U.S. Department of the Interior
BUREAU OF LAND MANAGEMENT

Notice of Intent

Type of Action: Plug and Abandonment

Notice of Intent – Plug and Abandonment

Planned P & A Wellbore Schematic

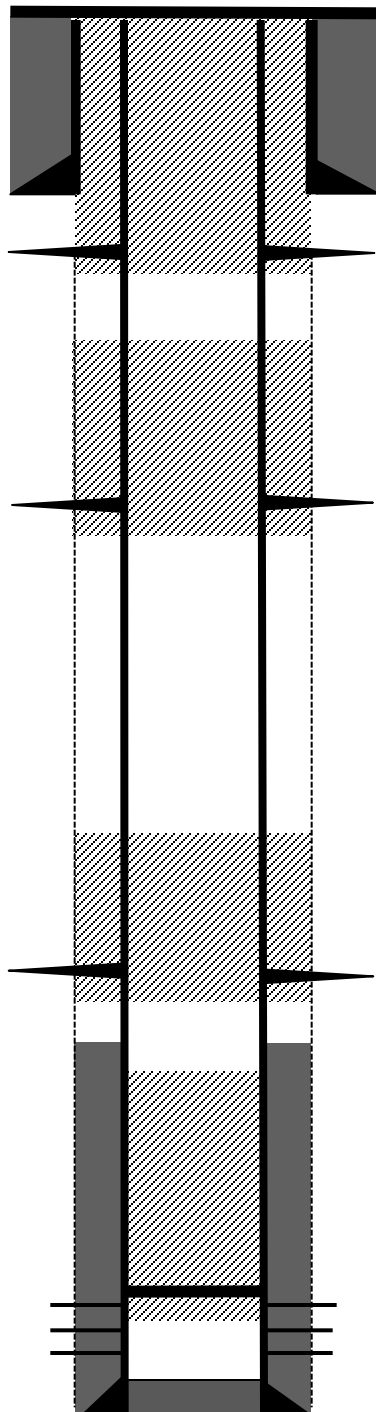
1. Plugging operations authorized are subject to the attached "General Requirements for Permanent Abandonment of Wells on Federal and Indian Lease."
2. The following modifications to your plugging program are to be made:
 - a. Modify Plug 3. Adjust the perforations and BOC to account for the BLM geologist's pick for the Nacimiento 890'. Setting perforations at approximately 940' is recommended.
3. **Notification:** Farmington Office is to be notified at least 24 hours before the plugging operations commence at (505) 564 7750.

Remarks: Please adjust all plugs to cover BLM-Picked formation tops.
